HISTORIC AND DESIGN REVIEW COMMISSION

March 01, 2017

HDRC CASE NO: 2017-076
ADDRESS: 817 NOLAN / 705 N PINE
LEGAL DESCRIPTION: NCB 549 BLK 9 LOT 5&6
ZONING: R-6 CD H
CITY COUNCIL DIST.: 2
DISTRICT: Dignowity Hill Historic District
APPLICANT: Willie A, JR & Guadalupe I Francois
OWNER: Willie A, JR & Guadalupe I Francois
TYPE OF WORK: 817 Nolan - Construction of a rear accessory structure, fencing, site work, exterior modifications to the existing wraparound porch / 705 N Pine – Fencing and landscaping

**Historic and Design Review Commission
Design Review Committee
Report & Recommendation**

817 Nolan Property Line

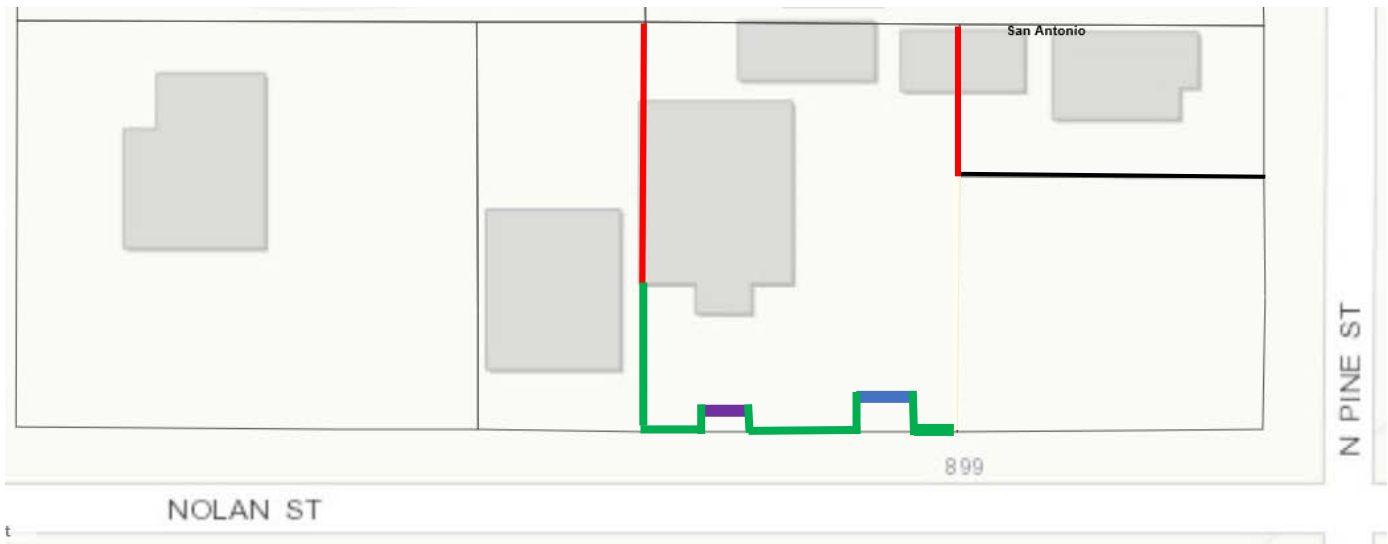
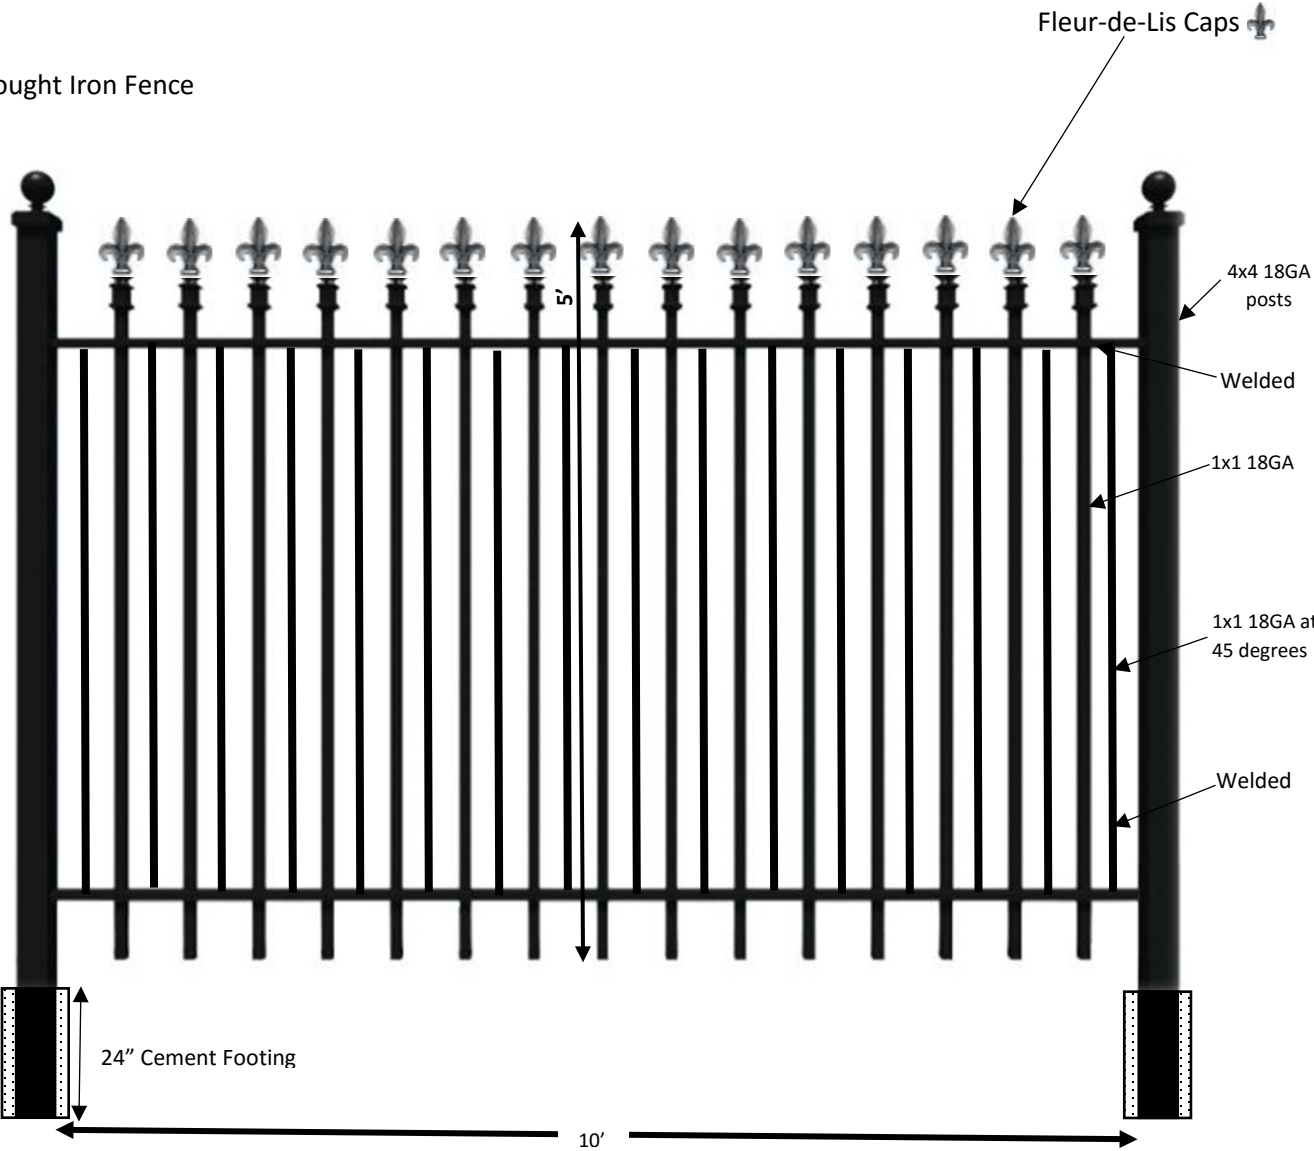
- i. FENCING – The applicant has proposed to enclose both lots, 817 Nolan and 705 N Pine with fencing. The applicant has proposed to install a six foot tall wood privacy fence to extent along the western property line to stop at the front façade of the property, a five foot tall iron fence along the public right of way at Nolan, a five foot tall iron gate and five foot tall rolling iron gate for the proposed sidewalk and driveway. At the lot line, the applicant has proposed to install a five foot tall wood post and wire fence and wood gate to extend along both Nolan and N Pine.

- j. FENCING – The Guidelines for Site Elements 2.B. states that fencing should appear similar to those found historically throughout the district in regards to transparency, scale and character, should be located where historically a fence would have existed and should not exceed four feet in height. Staff finds the proposed height and locations of the proposed fencing inappropriate. Historic fences throughout the Dignowity Hill Historic District do not feature recessed gates.

QUESTIONS REGARDING THE PATTERN OF FENCING ON NOLAN

STREET. IF NO HISTORIC PATTERN OF FENCES EXISTS, FENCES

SHOULD BE AVOIDED; IT APPEARS THAT FENCING MAY BE

- i. That the applicant install square columns on the proposed open air porch to complement those of the primary historic structure.
- ii. That the proposed front sidewalk and replacement steps feature a width consistent with sidewalks and steps found historically in Dignowity Hill.
- iii. That the applicant install fencing that does not exceed four feet in height except for the proposed privacy fencing.
- iv. That all gates be flush with perimeter fences.
- v. That the applicant submit fencing details to staff noting a height of four (4) feet and overall design.
